## BOARD OF ADJUSTMENT STAFF REPORT

### 972 Dogwood Drive

<b>Meeting</b>	<b>File No.</b>	<b>Application Type</b>
April 16, 2026	PZ-000434-2026-VAR-BOA	Variance
<b>Property Owner</b>	<b>Applicant / Authorized Agent</b>	
Johnathon and Shawn Capone	John Capone

**Request**  
 Consideration of a variance request from Land Development Regulation (LDR) Section 4.3.4(K), Development Standards Matrix – Residential zoning districts, to reduce the rear (south) setback to 5 feet, whereas a minimum of 25 feet is required, associated with the construction of a patio enclosure.

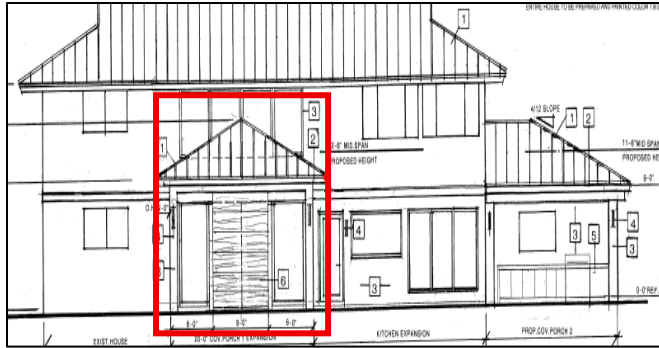
The request is to construct a patio enclosure in the rear setback (southside) of the property to increase the outdoor living space. Currently, the current residence consists of 3,188 SF of living space. The proposed patio enclosure is 19' 10" long and 20 feet wide with a total of 397 SF. The proposed patio enclosure is open on two sides and an eight-foot-high wall to accommodate for a TV and fireplace.

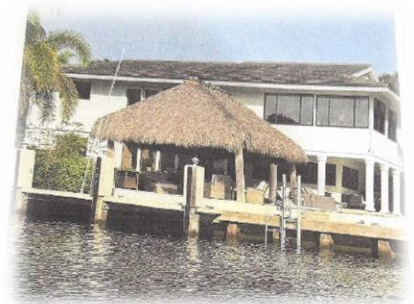
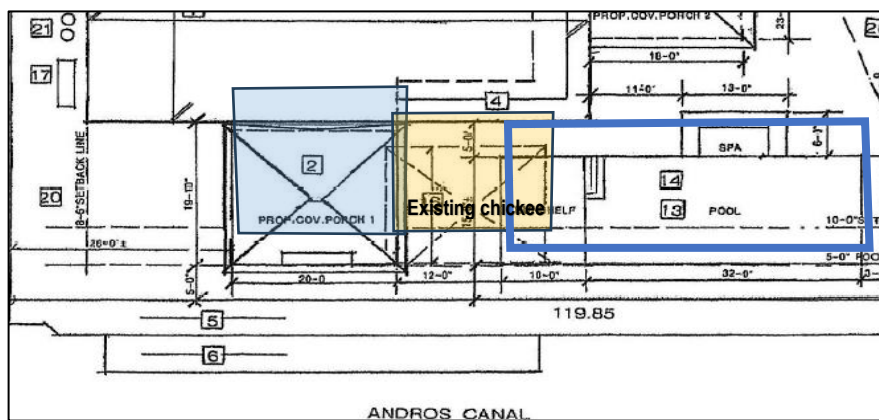
Currently, there is an existing chickee hut in the rear of the property. The proposed patio enclosure will replace the chickee hut and shift a bit to the east maintaining 20 feet side interior setback (west). The required side interior setback for R-1-AAB zoning district is eight feet five inches.

The Board shall consider as to whether the proposed covered patio to the rear of the property conveys that there are special conditions or circumstances related to the subject property and if the placement of the structure is the minimal needed to grant the variance.

The Board should also consider whether there are special conditions or circumstances that have not resulted from actions of the applicant. The house has not been altered since construction in 1981. While the 25-foot rear setback was in place for R-1-AAB in 1981, the unique shape due to the cul-de-sac makes it difficult to construct any additional covered areas around the pool. The LDR allows for a five-foot setback from the property line for a pool when adjacent to at least 50 percent of open space and a 10-foot setback for a screen enclosure with a solid roof. A screen enclosure is defined as "a framed structure completely covered with open mesh screening only. Such enclosure shall not have any type of opaque or transparent roof or sides such as glass or similar materials." Because the applicant is proposing a wall on the southside to accommodate for amenities, the patio enclosure does not meet the intent of a traditional screen enclosure.
